**PLANT 9 AND 2/3 REMOVAL ACTION WORK  
PLANS - INFORMAL DISPUTE RESOLUTION**

**DOE-158-91  
DOE-FMPC/USEPA  
5  
LETTER  
OU5**

OCT 25 1990  
DOE-158-91

Reference: Letter, Catherine A. McCord to Mr. Andrew Avel,  
"Approval of Plant 9 and 2/3 Work Plans," dated  
October 18, 1990

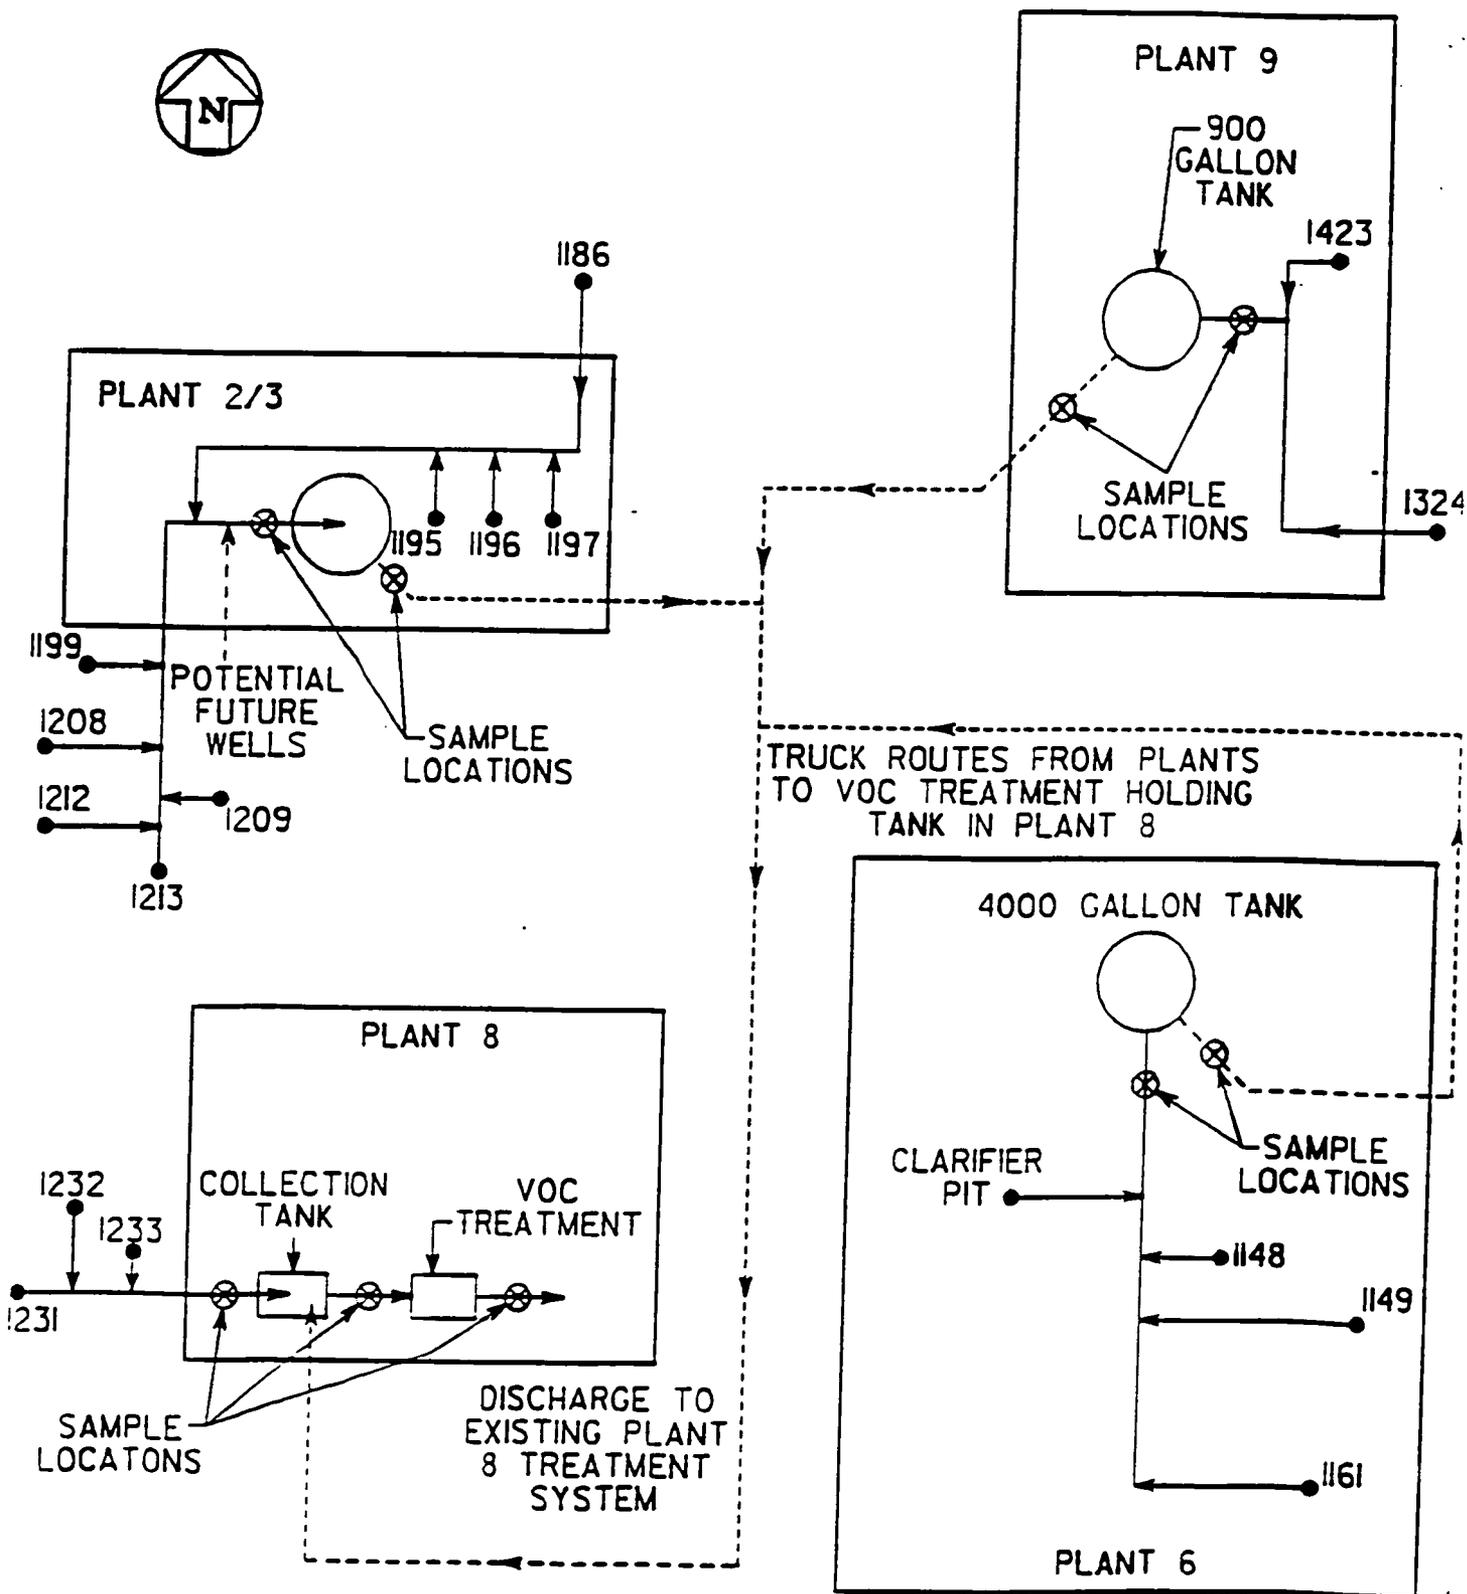
1. The Sampling and Analysis Plan in each of the work plans does not specify the location where samples will be collected. To adequately monitor the reduction of groundwater contamination (both VOC and radionuclide), it is necessary to collect groundwater samples at each collection point in a manner that will provide data which is a representative of the groundwater in that location. The sampling frequency may coincide with the frequency stated in the Sampling and Analysis Plan. After system start-up and verification, a subset of the hazardous substance list (HSL) and total radiological parameters (TRP) may be proposed for U.S. EPA approval. However, the full HSL and TRP must be analyzed annually to ensure that the selection treatment option continues to be adequate.

However, the U.S. DOE does not agree with item 1 requirements of the conditional approval. The sampling location proposed by U.S. DOE is described below:

The U.S. DOE has proposed an integrated system of collection and treatment of all perched groundwater beneath FMPC production areas (see enclosure 1) with centralized VOC treatment in Plant 8. The purpose of this integrated system is to provide compatibility with additional perched groundwater extraction wells which may be required in the future. Also, the integrated collection and treatment system is designed to reduce the number of samples which must be analyzed to provide representative data of the groundwater from a specific region and to ensure treatment efficiency. Requiring the collection of groundwater samples at each collection point would reduce the benefits realized by integrating FMPC perched water collection and centralized treatment. The proposed sample locations for the integrated perched groundwater collection and treatment system are shown on enclosure 1. These nine sample locations depicted should provide sufficient data to monitor the reduction of groundwater contamination using the sampling frequency and

analysis presented in the Plant 9 and 2/3 Work Plans. The sample locations depicted before and after the VOC treatment system will provide the required data to determine the removal efficiency of the treatment system. A full HSL and total radiological sample was collected and submitted from each extraction well in July 1990 to determine the initial level of contamination at each well. The results of only five of these samples has been received to date. The semi-volatile analysis holding times were exceeded by the laboratory for eight of these HSL samples collected in July 1990. These wells will be resampled for semi-volatile analysis only in late October 1990. Annual HSL and TRP sampling of each extraction well could be performed as stipulated by U.S. EPA.
